RE: Willow Pass Generating Station AFC

CEC Docket No. 08-AFC-6

Responses to the December 19, 2008 **Issues Resolution Workshop**

Application for Certification (08-AFC-6)for WILLOW PASS GENERATING STATION Pittsburg, California

Figure 4-1 City of Pittsburg's Implementation Ordinance for the HCP/NCCP: Development Fee Zone Map

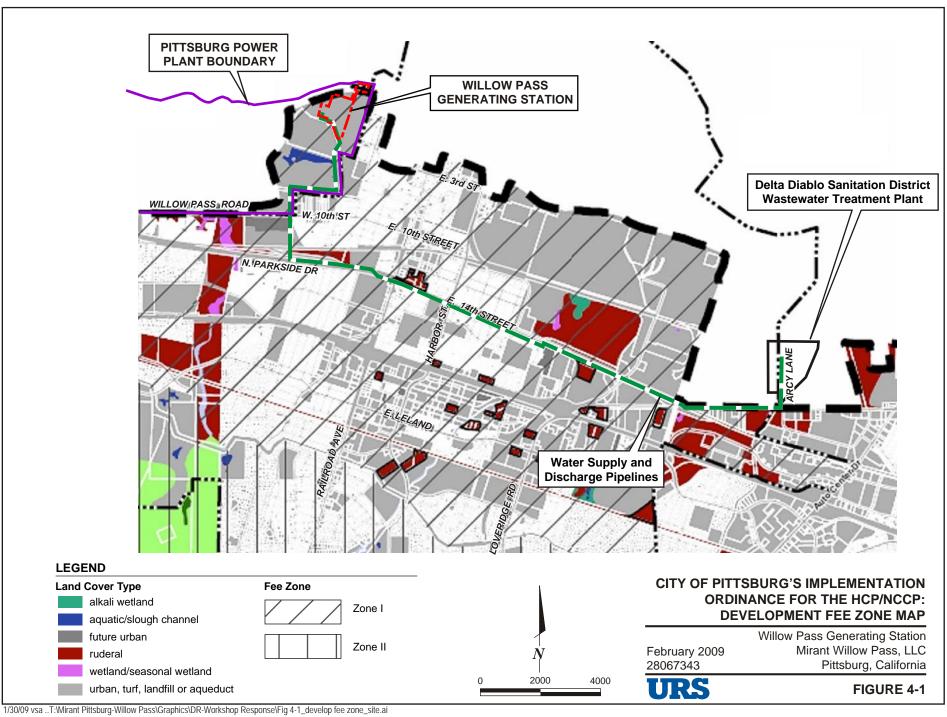
3. The Pittsburg Ordinance also states exemption for "Any development project that the City Planner determines is contained entirely within an area mapped as urban, turf, landfill and/or aqueduct land cover types in the HCP/NCCP, as generally depicted on Exhibit A..."

As defined in the Development Fee Zone Map of the Pittsburg Ordinance (attached as Figure 4-1), the WPGS and the offsite water supply and discharge pipelines will be constructed primarily within urban, developed areas. The one exception is the proposed offsite water pipelines alignment within the railroad switchyard, which is defined under the ordinance as ruderal habitat. Most impacts to this area will be avoided through the use of microtunneling; remaining impacts will be temporary in nature.
